Docket Item # 1
BAR CASE # 2011-0042

BAR Meeting
July 27, 2011

ISSUE: Alterations
APPLICANT: Annette Wietecha (Ned Ponder, Agent)
LOCATION: 415 North Payne Street
ZONE: RB / Residential

BAR CASE #2011-0042

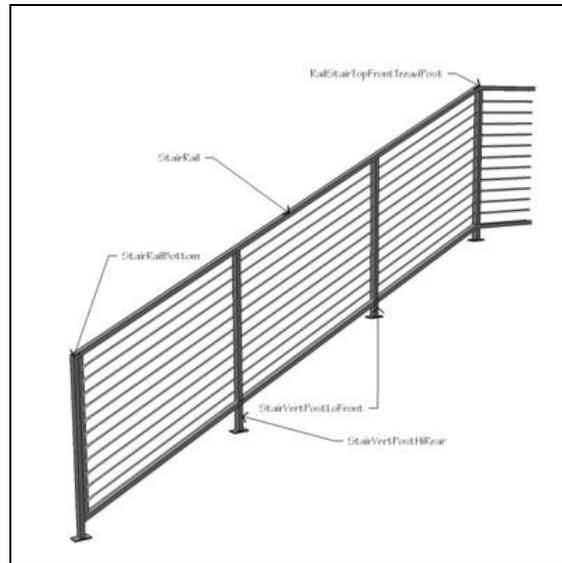
The applicant has provided drawings illustrating the details for the custom balustrade and awning. After reviewing these new drawings, Staff is recommending small modifications to the balustrade's design which will create a more streamlined and simplified architectural feature. The suggested modifications include mounting the cable wire horizontally instead of

vertically and be spaced in compliance with Virginia Residential Code sec. R312; revising the detail on the metal newel posts so they do not extend above the height of the guardrail (this is a requirement of Virginia Residential Code sec. R311.7.7.2); and specifying that the metal used on the awning and the balustrade as stainless steel. These changes will allow for a railing design similar to that illustrated below:

1. That the cable wire balustrade will be mounted horizontally instead of vertically and be spaced in compliance with Virginia Residential Code sec. R312;
2. That the metal newel posts on the balustrade will not extend above the height of the guardrail;
3. That the metal used on the awning and the balustrade will be stainless steel.
